BikeWalkSolana Comments on Phase III Workshop – May 29, 2019³

BikeWalkSolana supports all the objectives of the Lomas Santa Fe (LSF) Corridor Improvement Project to create an attractive transportation environment for our major east-west arterial through Solana Beach:

Class I Multi-Use Trail Cross Section @ May 29 Workshop

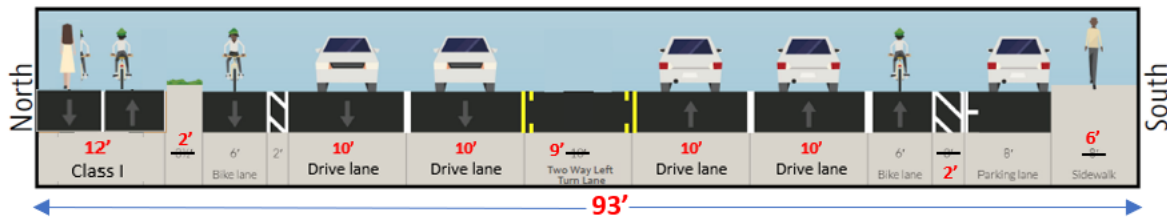
- a. After reviewing these options, BikeWalkSolana prefers the Multi-Use path and would like the City to consider our primary recommendation to widen the western section Multi-Use path to a more comfortable 12'.

- b. The primary reason for not supporting the Multi-Use Class I facility exactly as presented on May 29 is that a width of 4' each way for 2-way bicycle traffic is too narrow, especially since this is to be shared with pedestrians, strollers, dogs, and portions will involve grades where bicycle head-on collisions need to be eliminated. If that could be widened to *at least* 6' each way, that would improve the safety and the aesthetic appeal of the facility. By narrowing the travel lanes per Hwy 101 dimensions, extra width for the Class I path would be available. Also, the concrete separation could be narrowed to 2' as in the Cycletrack Class IV option because the bike lane provides additional separation. It would be great to have a clear part of the path marked for pedestrians because one of the attractive features of the Cycletrack option is that it is for bicycle use only, whereas the Multi-Use path needs to be wider as a shared path.

Suggested Width Modifications to Multi-Use Trail Narrower lanes, wider path, No Right of Way Required
